Sydney Metro Martin Place

North Tower Base Building Changes

SSD/ MOD drawings & FC2 Comparison

Rev #02 – 26/10/21

Level 30 Plan

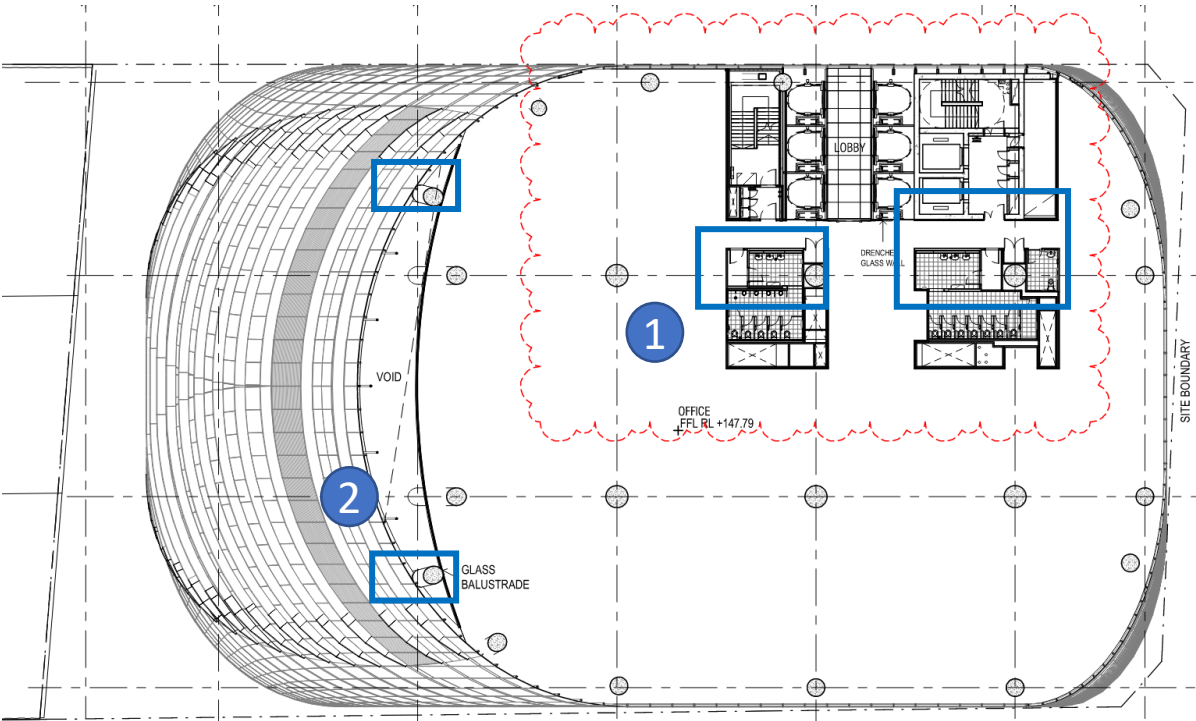
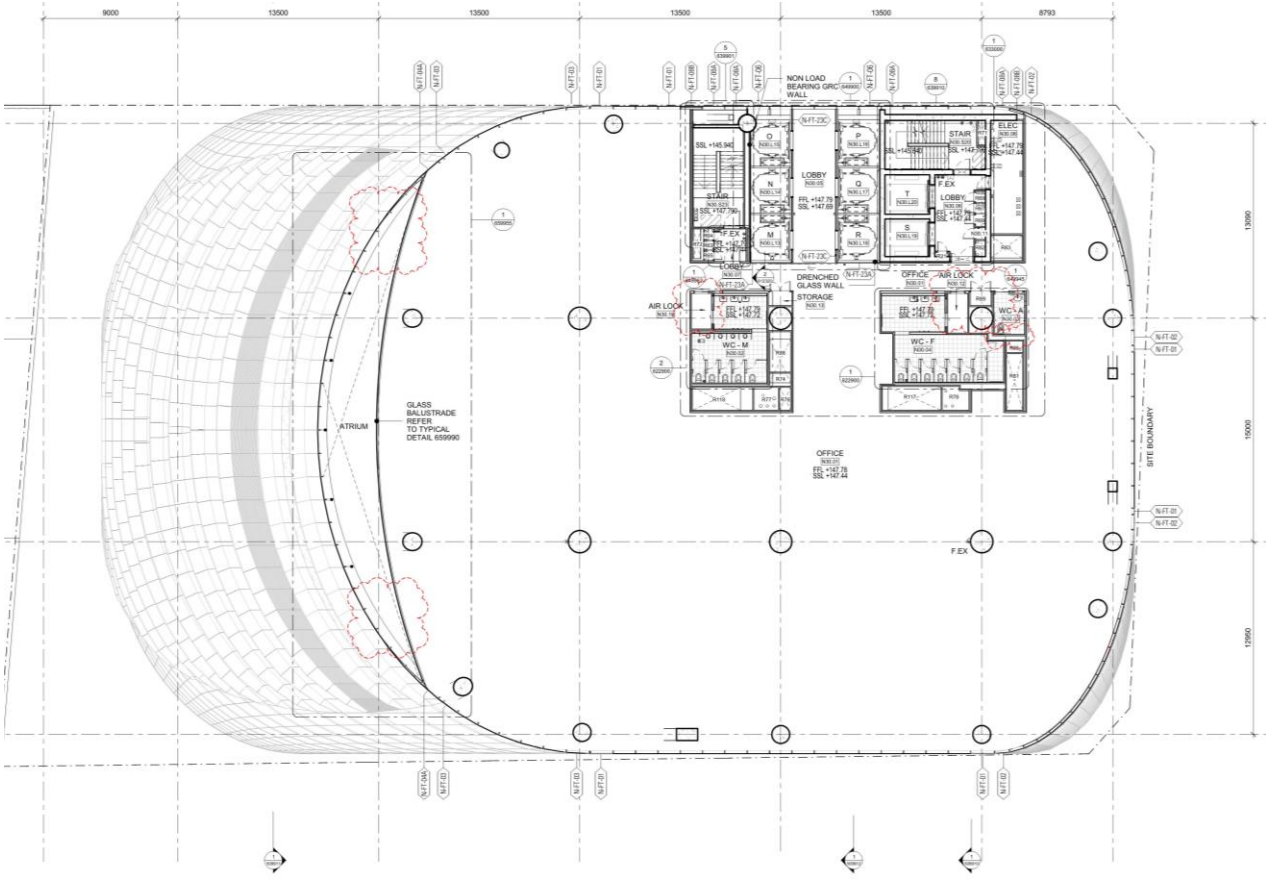
- 1. BOH layout revised
- 2. Columns deleted

Level 31 Plan

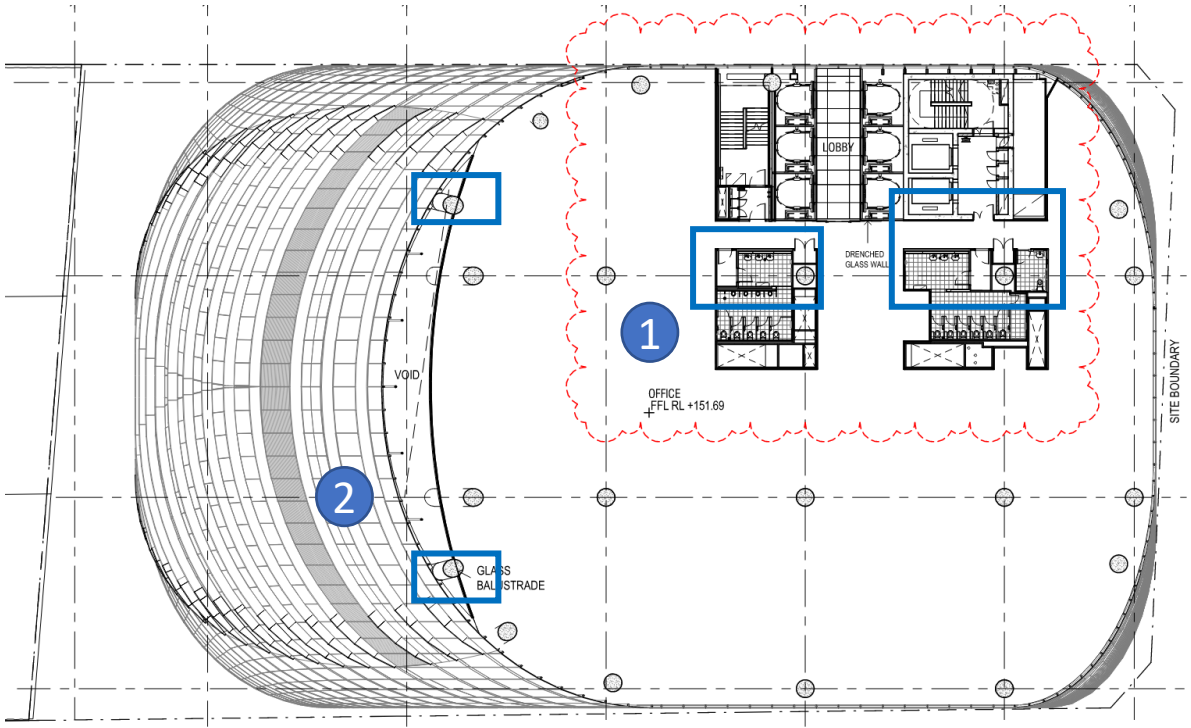
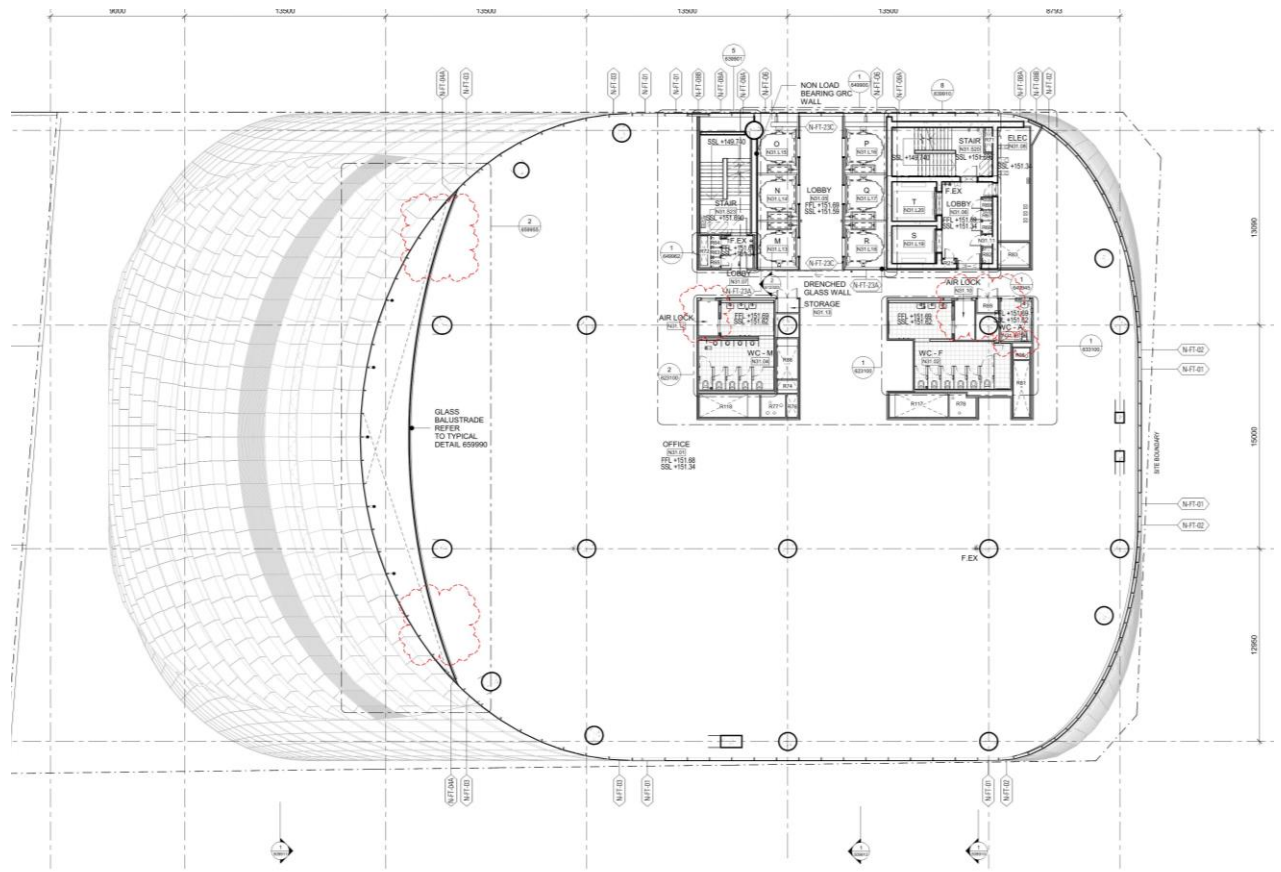
- 1. BOH layout revised
- 2. Columns deleted

Level 32 Plan

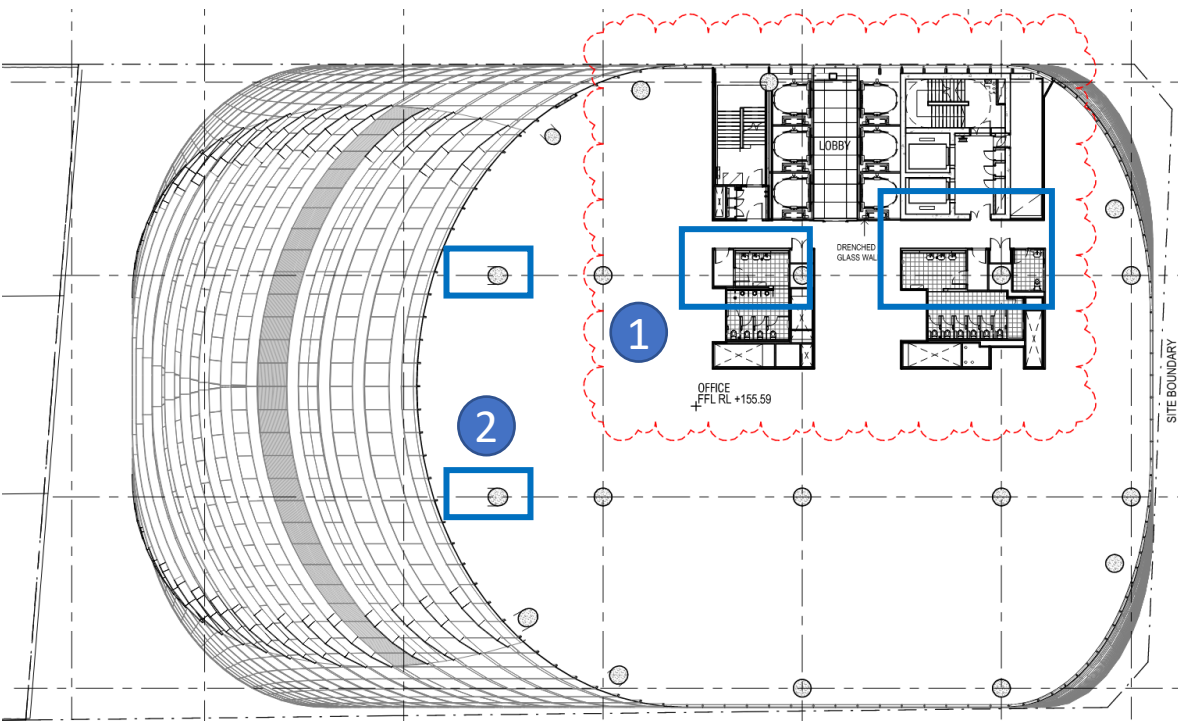
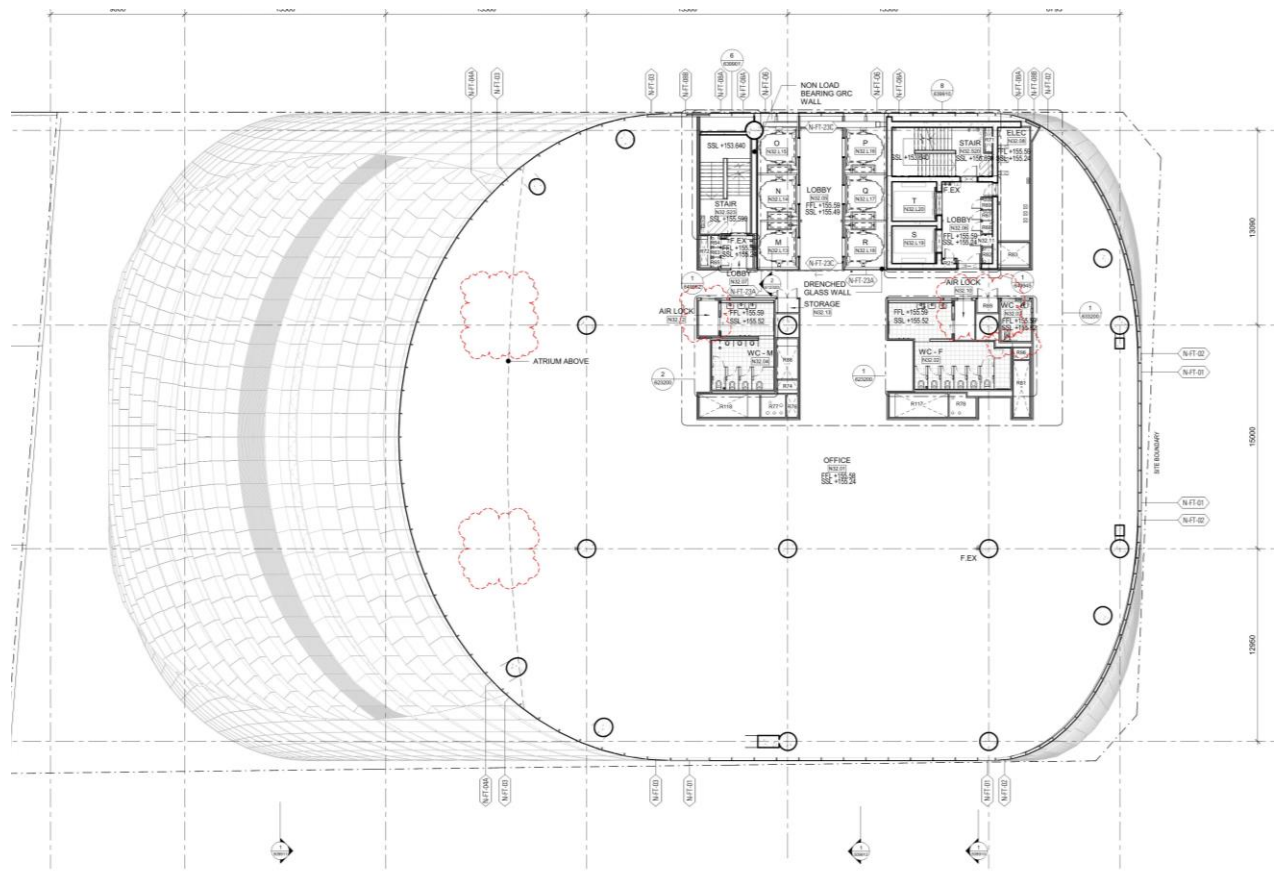
- 1. BOH layout revised
- 2. Columns deleted

Level 33 Plan

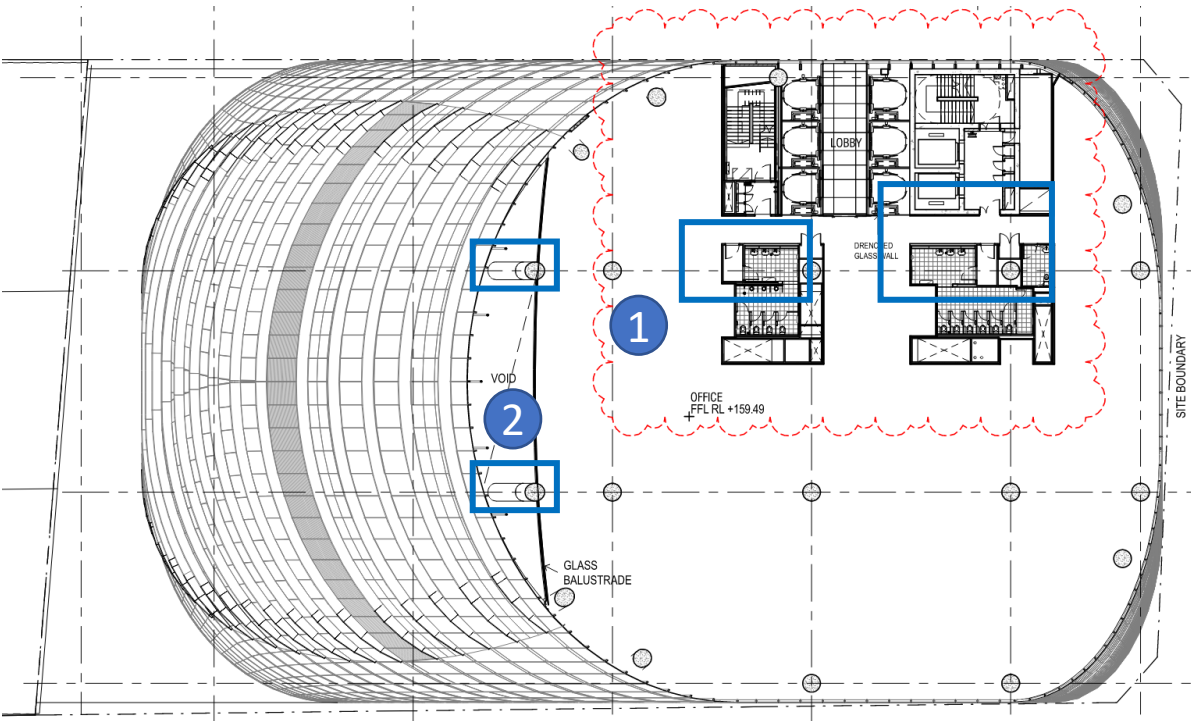
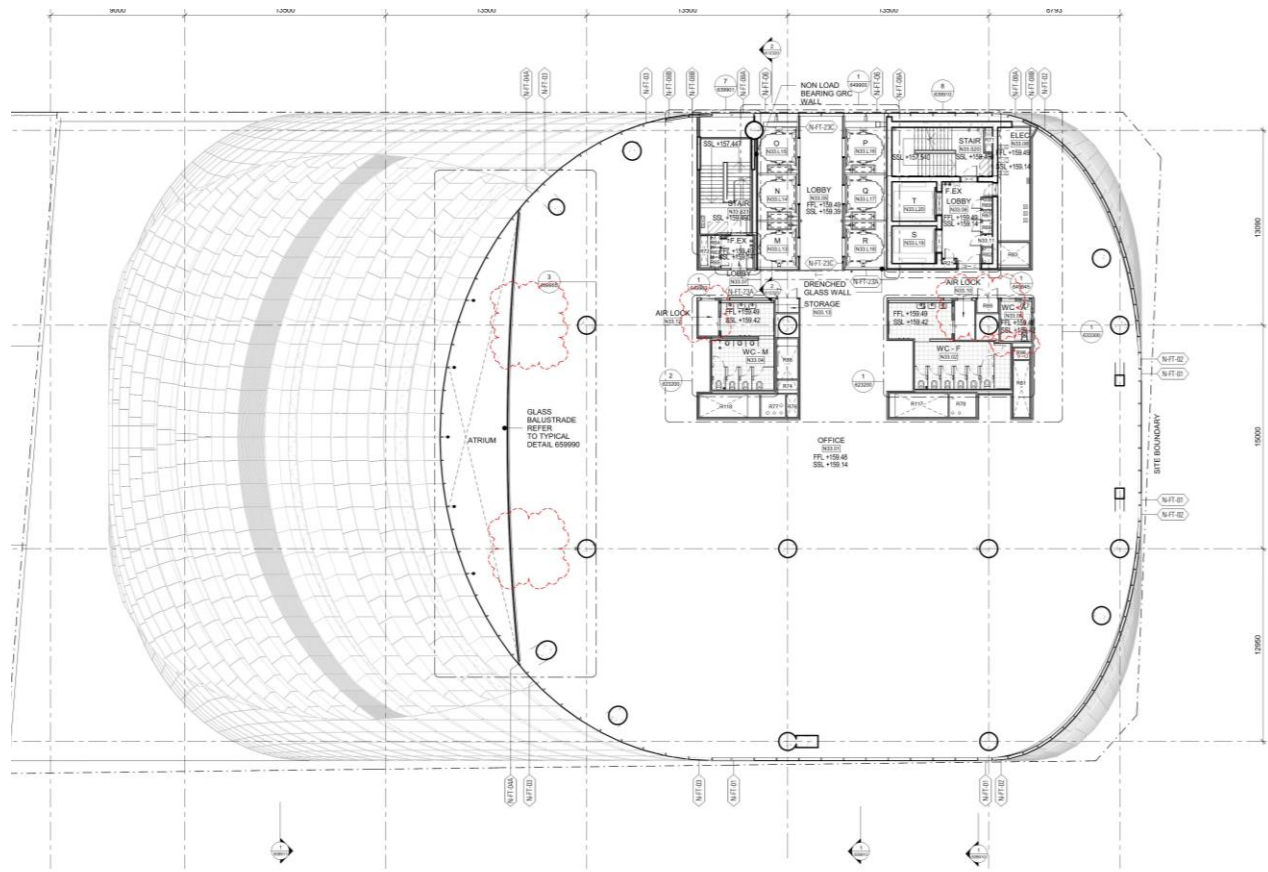
- 1. BOH layout revised
- 2. Columns deleted

Level 34 Plan

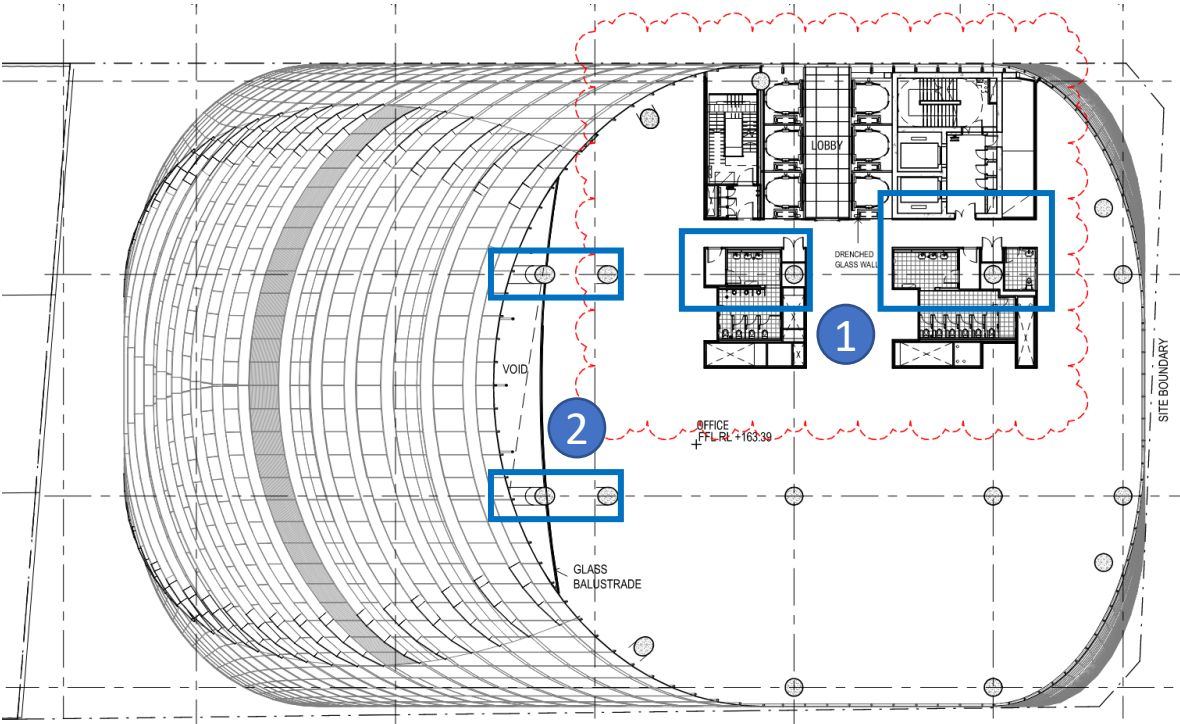
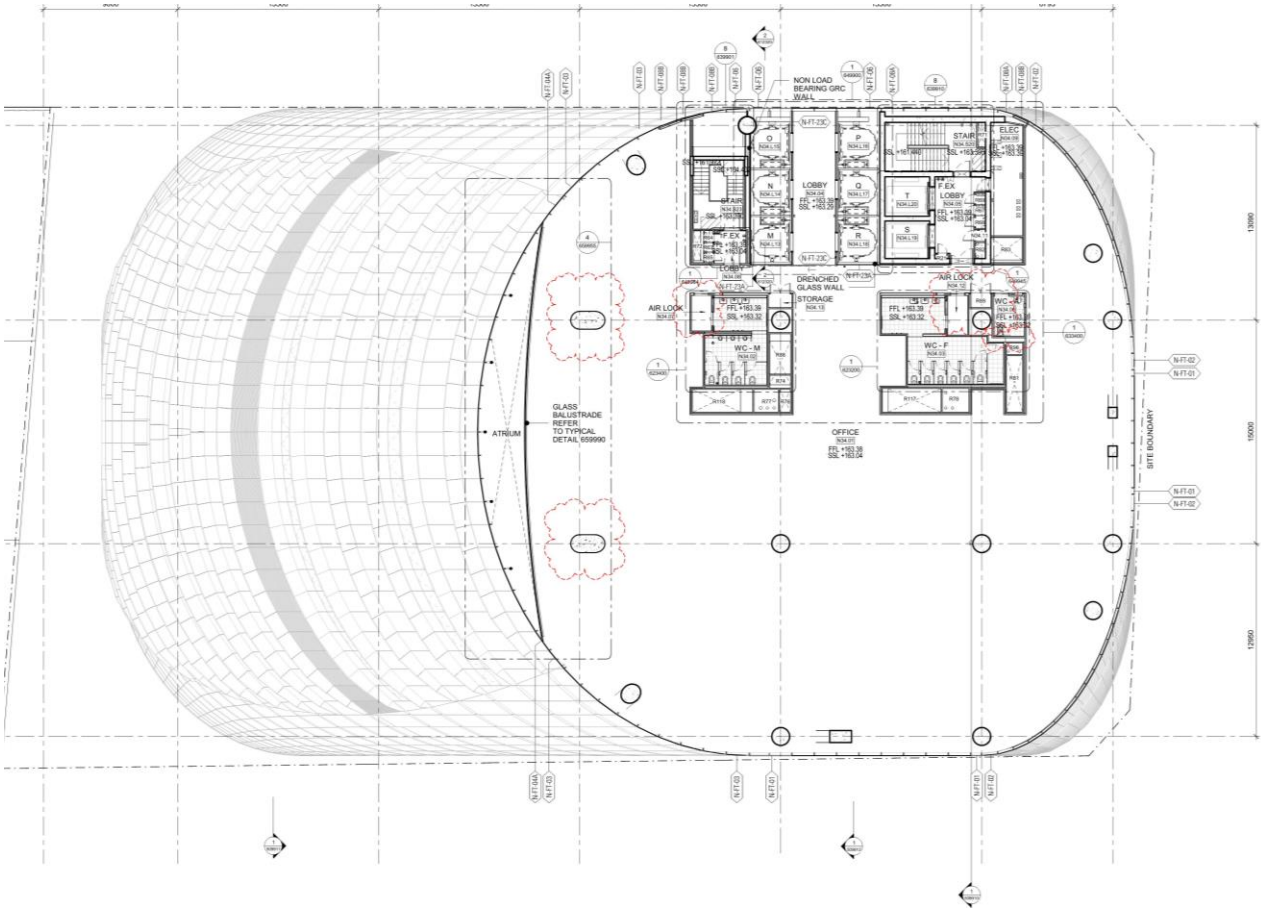
- 1. BOH layout revised
- 2. Columns revised
